Contract #: 04-0120F4Cty: SF/ALA Rte: 80 PM: 13.2/13.9File #: 69.25B**QUALITY ASSURANCE -- NON-CONFORMANCE REPORT****Location:** Zhenhua Port Machinery Company, Ltd - Changxing Island**Report No:** NCR-000011**Prime Contractor:** American Bridge/Fluor Enterprises, a JV**Date:** 04-Oct-2007**Submitting Contractor:** Zhenhua Port Machinery Company, Ltd (ZPMC), Changxing Island**NCR #:** ZPMC-0011**Type of problem:**

Subject: NCR No. ZPMC-0011

Reference Description: Failure to document fit-up of longitudinal stiffener on Mock-up

SUBJECT: RESPONSE TO NCR-11, 12 AND 13

美国钢塔 / 钢桥面板与纵向筋 (U肋) 及横隔板装配检查记录卡
Rib, diaphragm assembly with surface plate checking

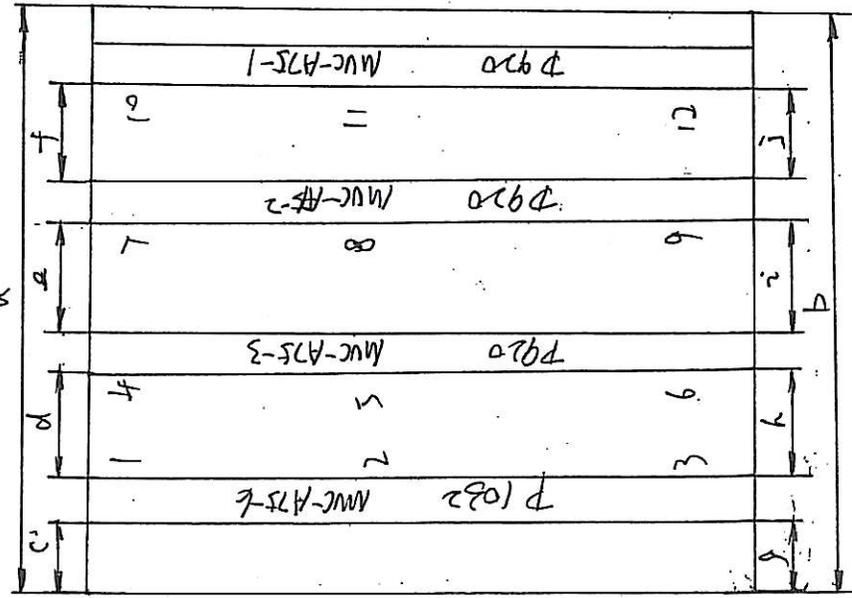
ZPMC has generated internal NCR-CT-013 in Response to NCR-000011-CT, ^{11 P.L. 12/25/07} Regard that there are no marking visible on the part documenting QC acceptance of fit p920-3 and MUC-A75. we have checked the visible marking on the plate and we have submitted the assemble report to prove it fit-up well.

ZPMC submitted the inspection record for the piece which documents the QC inspection of the fit up and verification of the dimensions. ZPMC also issued an internal NCR to document the incident.
